Exhibit A
Proposed Reliability Standard TPL-001-5

TPL-001-5 Clean Version

1. **Title:** Transmission System Planning Performance Requirements
2. **Number:** TPL-001-5
3. **Purpose:** Establish Transmission system planning performance requirements within the planning horizon to develop a Bulk Electric System (BES) that will operate reliably over a broad spectrum of System conditions and following a wide range of probable Contingencies.
4. **Applicability:**
 - 4.1. **Functional Entity**
 - Planning Coordinator.
 - Transmission Planner.
5. **Effective Date:** See Implementation Plan.

Figure 5–12 — Station DC Supply and Monitoring

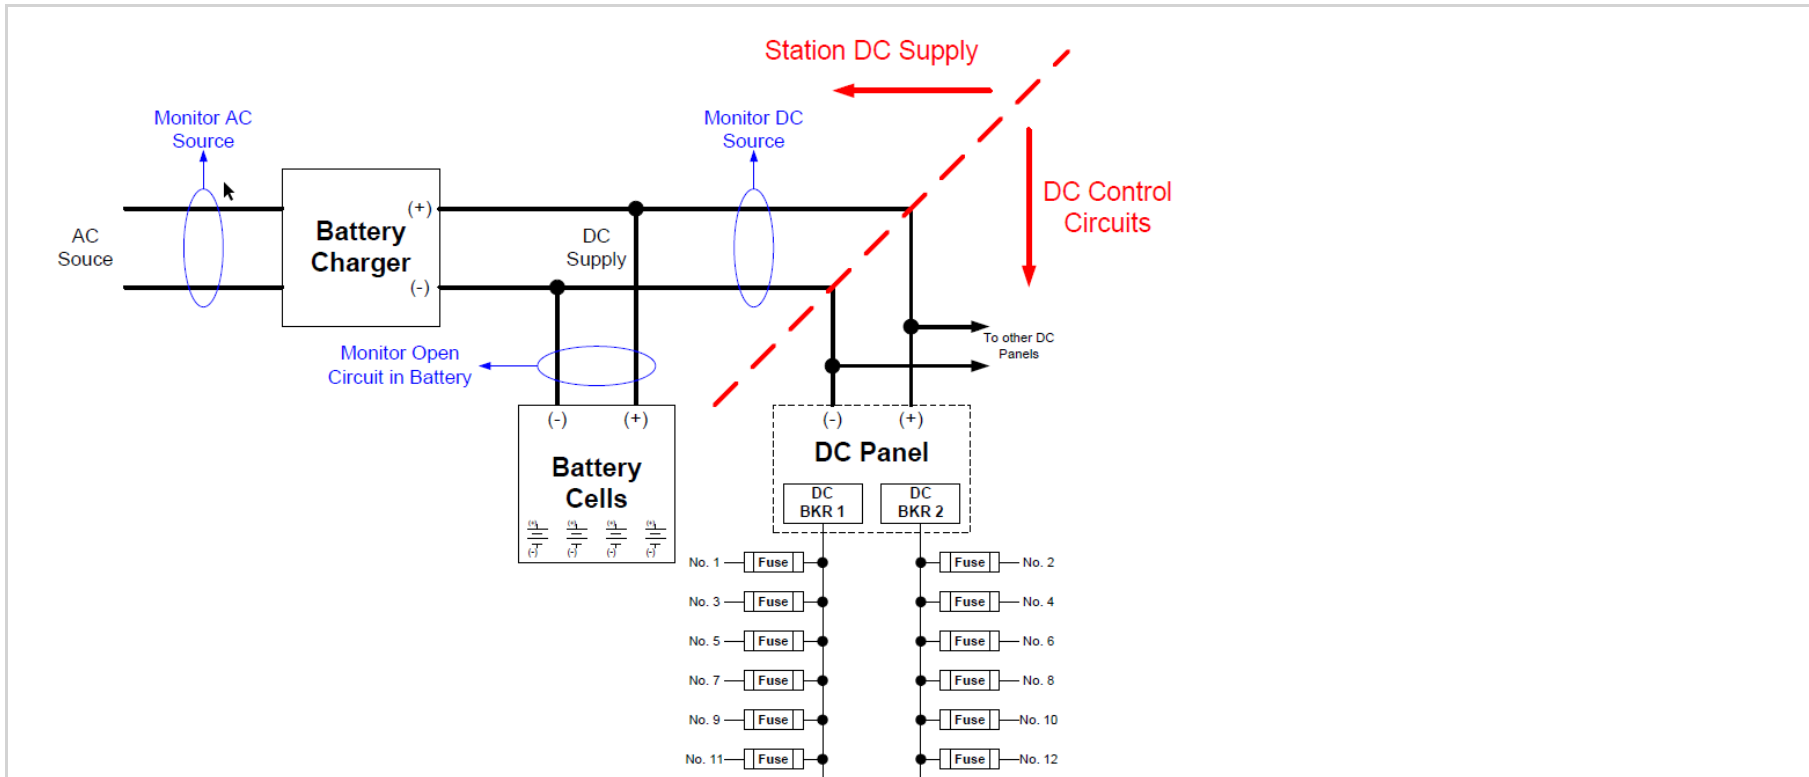
Document Name	
Comment	
<p>Hydro One still has concerns with the following points regarding Footnote 13:</p> <ol style="list-style-type: none"> 1) 13c – The term “open circuit” is not clear. Please provide clarification of the term and an example of how it is typically monitored in the supplementary material for better understanding. 2) 13d – We recommend that a single trip coil that is “monitored and reported at a Control Center” be treated the same way that communication systems (Footnote 13b) and DC Supply (Footnote 13c) are treated (to meet the redundancy requirement). 	
Likes	0
Dislikes	0

Response	
<p>1) There is a NERC Technical Paper dated November 2008 titled “<i>Protection System Reliability Redundancy of Protection System Elements</i>” which explains why monitoring an “open circuit” is required. The SAMS and SPCS recommendation from Order No. 754 and Section 1600 data request aligns with most of the elements in the NERC Technical Paper. For reference Figure 5-12 is copied from this technical paper.</p>

2) Monitoring was added to footnote 13d.
